# Access Compliance Report

## Public Rights-of-Way

Intersection ID: 12958	Main Street: E_3RD_ST	Cross Street: S_DAVIDSON_ST	Location: S
ADA ID: B12A82929244	Ramp Type: PerpDiag	Initial Pass/Fail: Fail	Overall Compliance: No
		Severity Score: 12.5

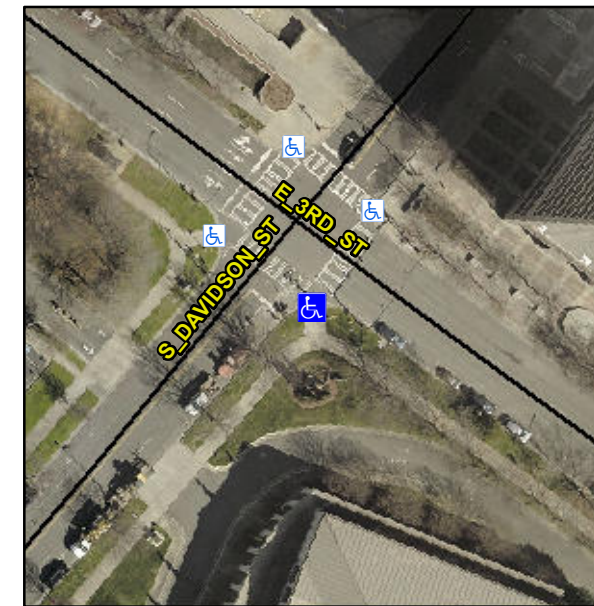
Compliance	Description	Data	Compliance	Description	Data
N/A	Ramp Length (in)	108.0	Yes	Ramp Slope (%)	4.0
Yes	Ramp Width (in)	60.0	No	Ramp XSlope (%)	5.1
N/A	Flare Type LT	N/A	N/A	Flare Type RT	N/A
N/A	Flare Slope LT (%)	N/A	N/A	Flare Slope RT (%)	N/A
N/A	Flare Traversable LT?	N/A	N/A	Flare Traversable RT?	N/A
N/A	Landing Length (in)	N/A	N/A	DWS Provided?	N/A
N/A	Landing Width (in)	N/A	N/A	DWS Contrast?	N/A
N/A	Landing Slope (%)	N/A	N/A	DWS Length (in)	N/A
N/A	Landing X Slope (%)	N/A	N/A	DWS Full Width?	N/A
N/A	Landing Curb? (Y/N)	N/A	N/A	DWS Offset (in)	N/A
N/A	Shared Landing?	N/A			
N/A	Gutter Ponding?	N/A	N/A	Gutter Slope (%)	N/A
N/A	Gutter Lip Ht (in)	N/A	N/A	Gutter X Slope (%)	N/A
N/A	Painted X Walk1?	Yes	N/A	Painted X Walk2?	Yes
	X Walk 1 Direction	To NE		X Walk 2 Direction	To NW
N/A	X Walk 1 Width (in)	128.0	N/A	X Walk 2 Width (in)	114.0
	X Walk 1 Slope (%)	1.4		X Walk 2 Slope (%)	3.5
	X Walk 1 X Slope (%)	3.6		X Walk 2 X Slope (%)	0.6

**Remove & Replace Curb Ramp With Two New Directional Ramps or Equivalent.**

**R304.5.3**
